**Addendum #1 for
RFCSP752-25-1012CS
Kerr Hall Dining
(Treanor's Addendum #4 for
the project)**

ADDENDUM NO. 4

PROJECT: UNT Kerr Hall Dining Renovation
HE0569.2302.01

DATE: 07/03/2025

DEMOLITION RCP

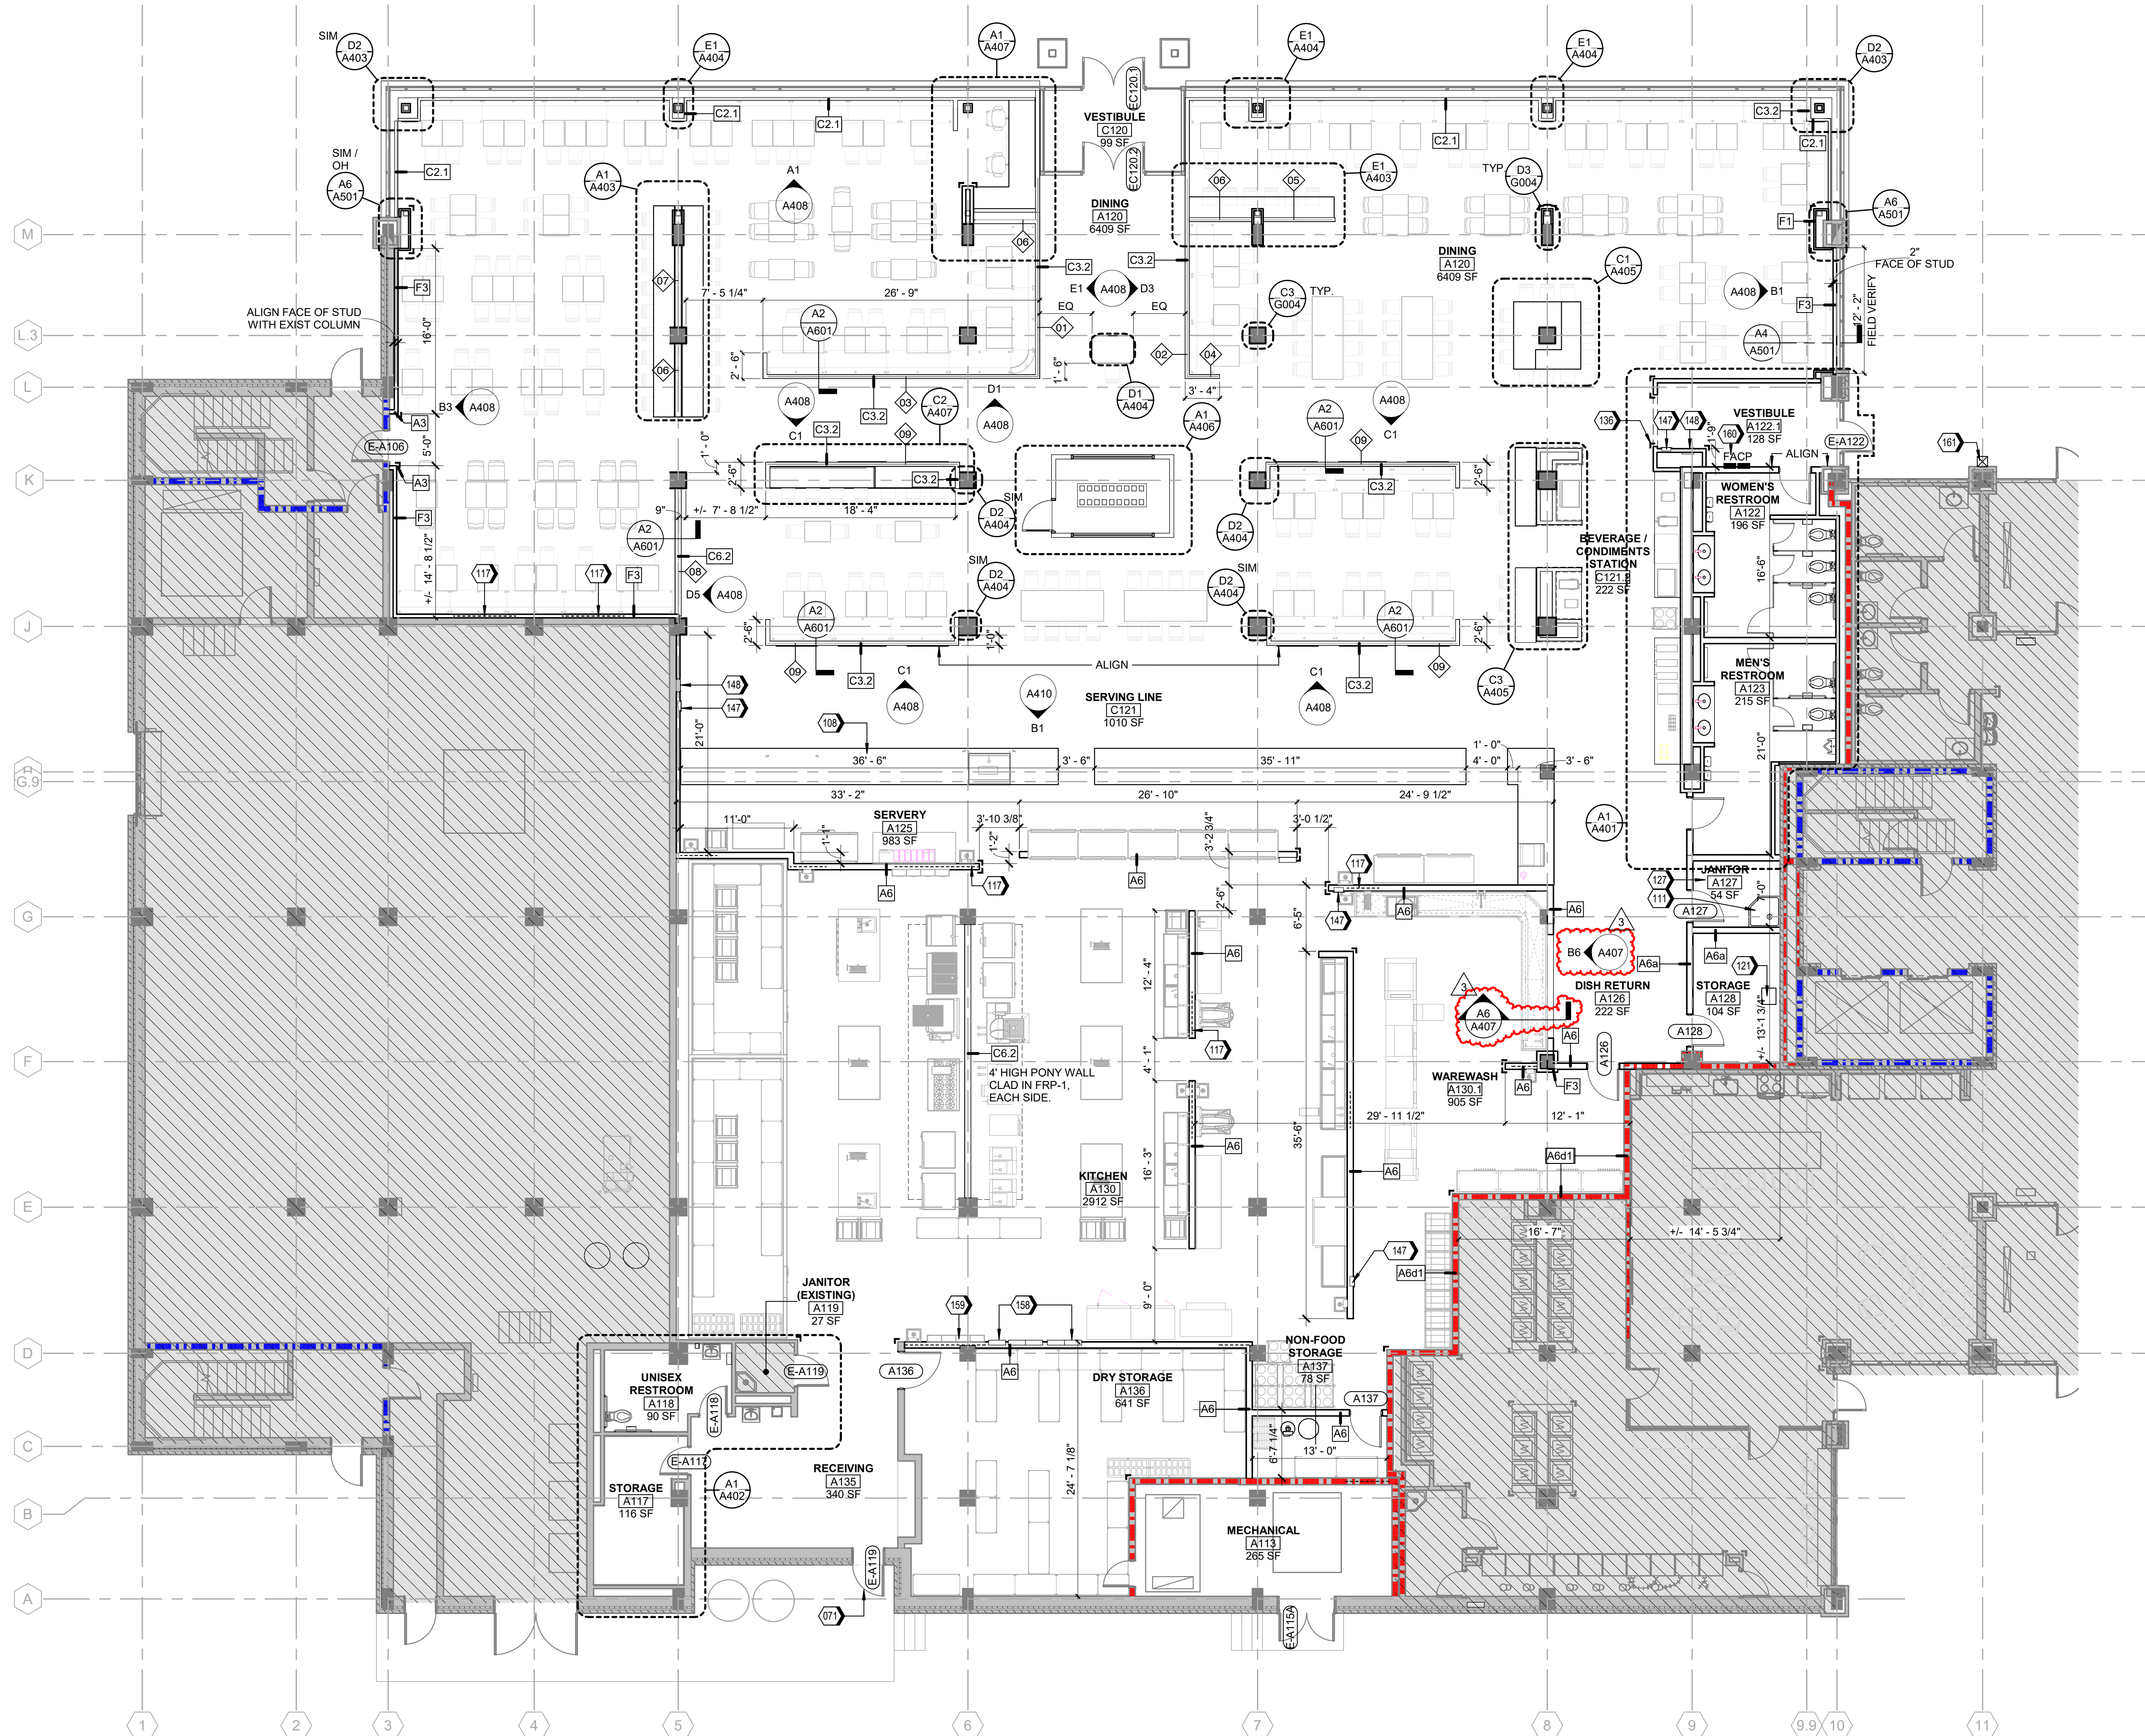
- AD151 – DEMOLITION RCP
 - Revised keynote 044 to clarify that all existing lighting is to be removed.
- A101 – FLOOR PLAN (KITCHEN & DINING)
 - Tags for elevation B6/A407 and section A6/A407 added to the floor plan.
- A151 – REFLECTED CEILING PLAN (KITCHEN & DINING) – BASE BID
 - Base Bid vs Alternate Scope clarified for Alternate #1.
 - Tag for section A3/A510 added.
- A401 – ENLARGED PLANS & INTERIOR ELEVATIONS

SECTION - TIERED COUNTER SEATING 2 C5
1 1/2" = 1'-0"

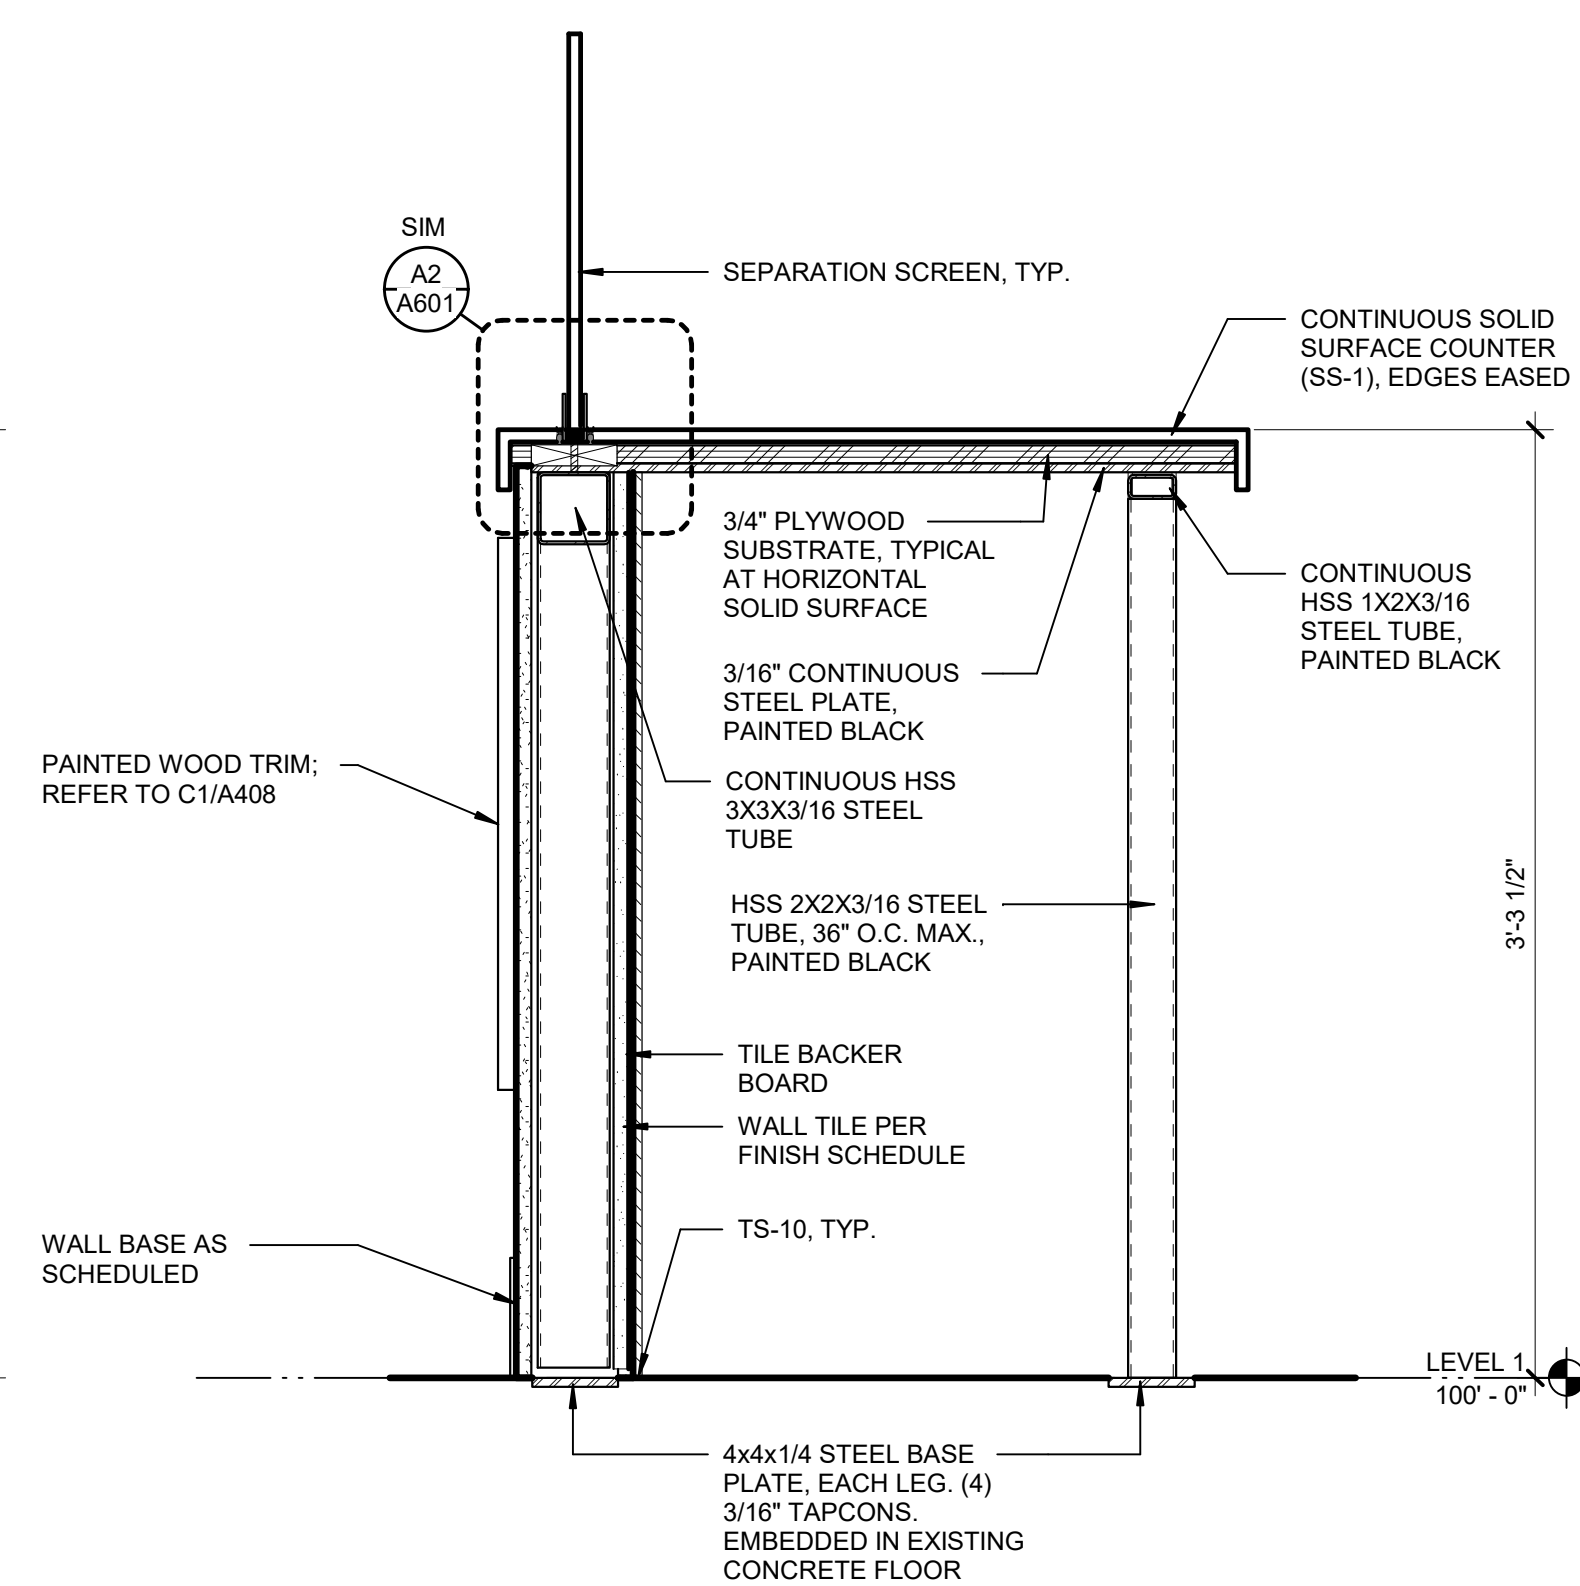
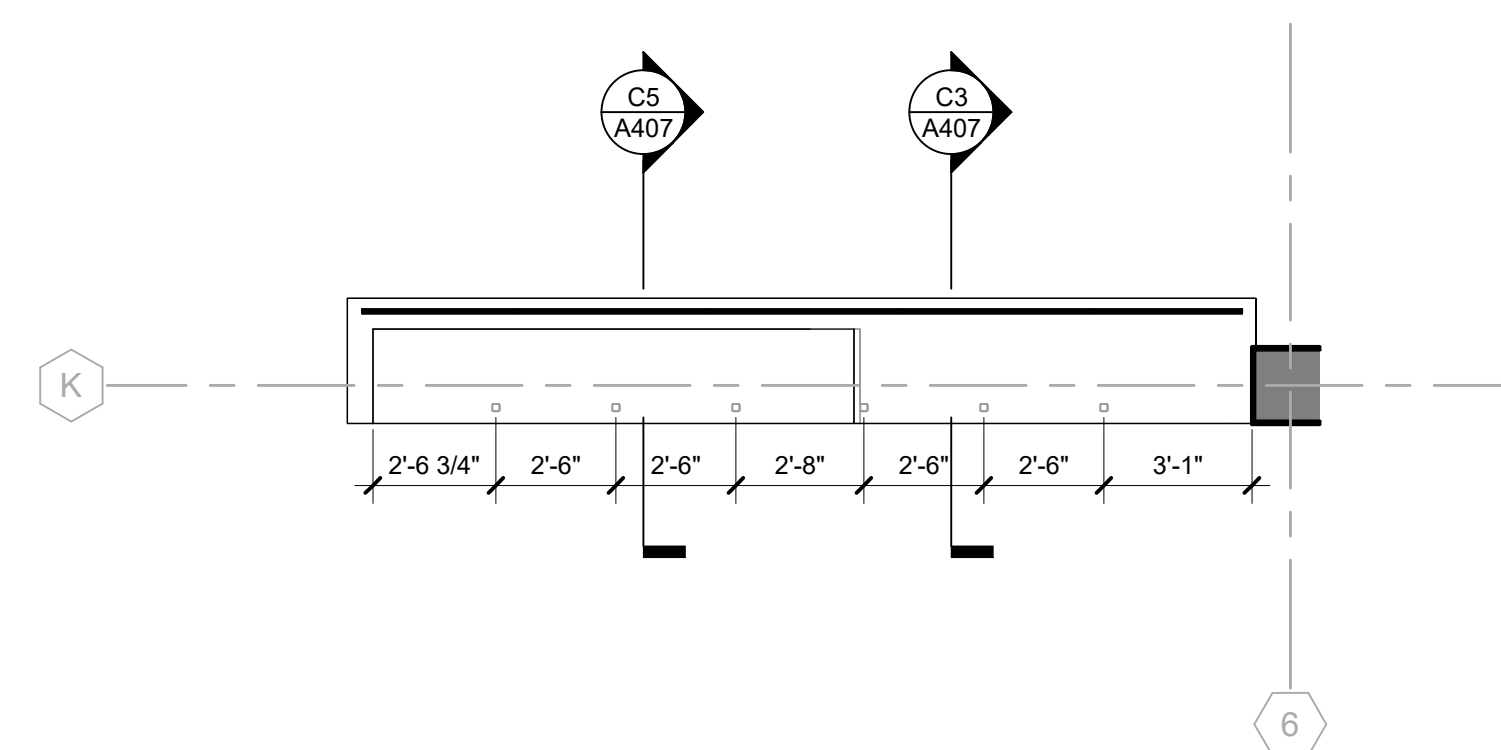
26. RFI #64 response indicated details E2/A403, A4/A403, C3/A407, and C5/A407 were to be clarified in the addendum to show cold formed metal framing between tube steel. However these details were not updated in any of the addenda. Please revise details to show these changes.

DISH RETURN - SECTION A6
1" = 1'-0"

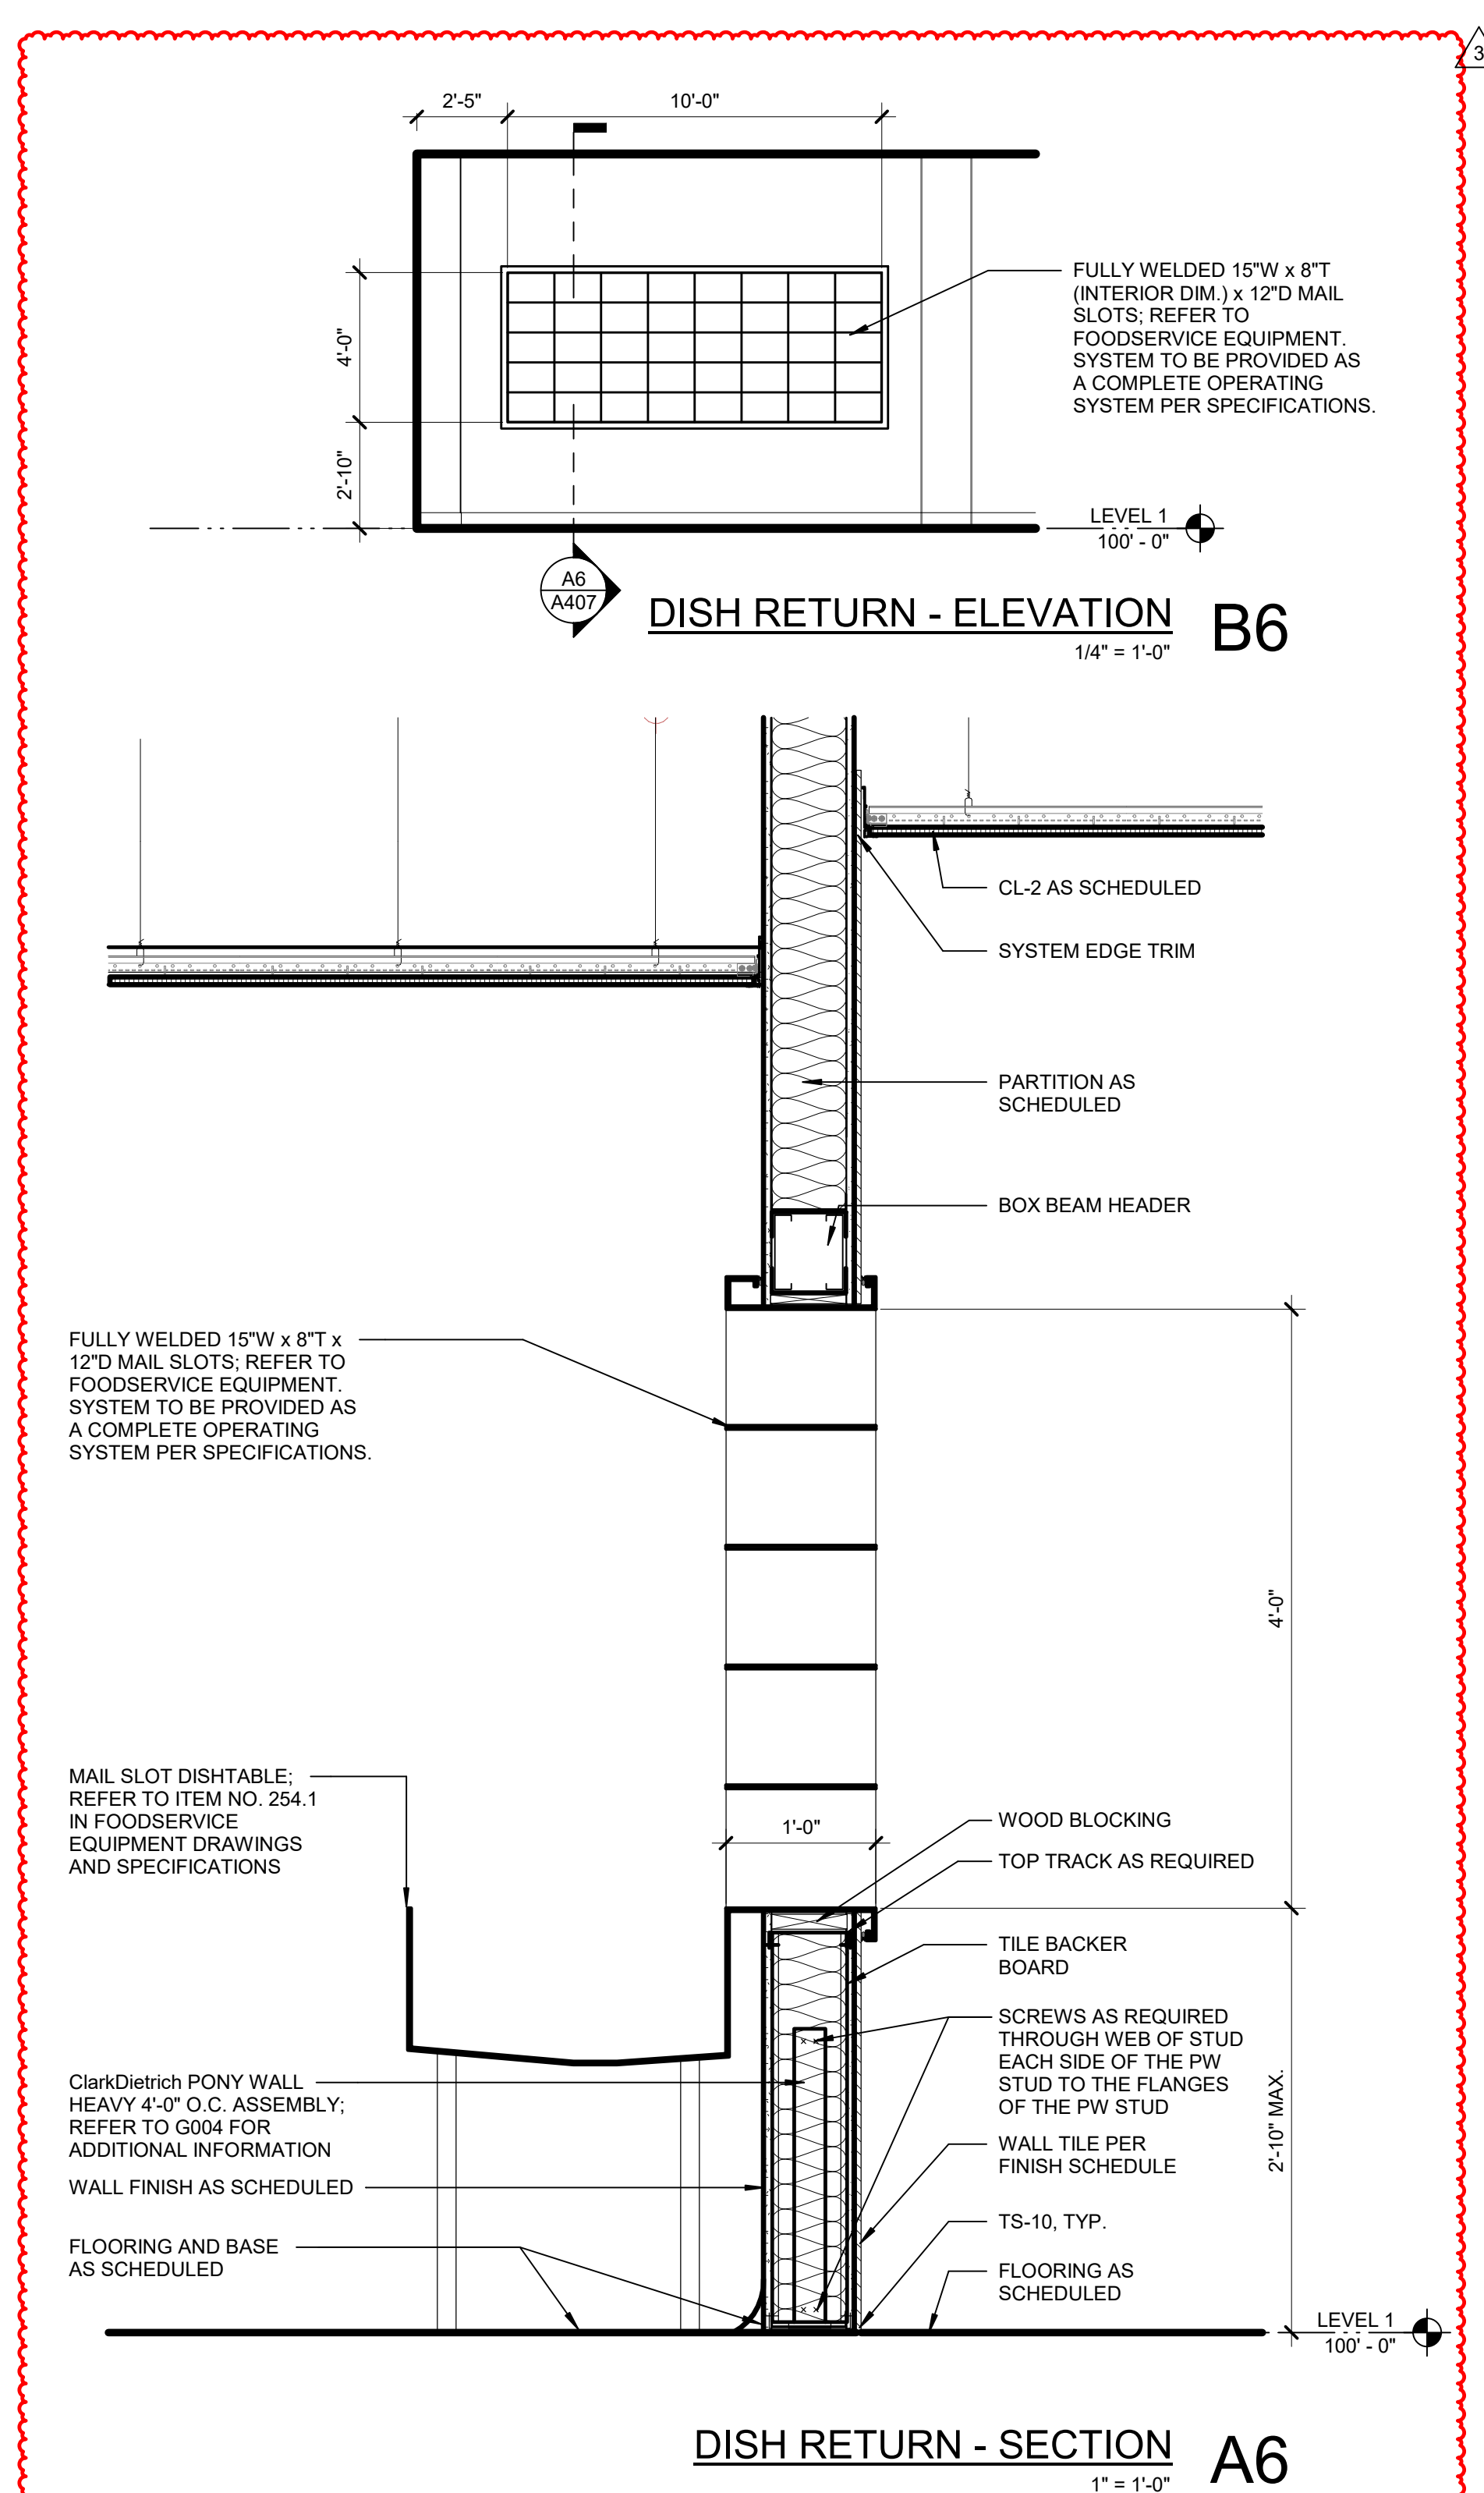
15.	<p>Please provide the framing detail and elevation of the west wall of Dish Return A126 at the mail slot tray drop window as indicated in RFI #58 response. These details were not included in the previously issued addenda.</p> <p>Refer to A6 and B6 on sheet A407.</p>

- A405 – ENLARGED PLANS, INTERIOR ELEVATIONS, & DETAILS
 - Detail E3/A405 added.
- A407 – ENLARGED PLANS, INTERIOR ELEVATIONS, & DETAILS
 - Section A6/A407 added clarifying dimensions of dish return.
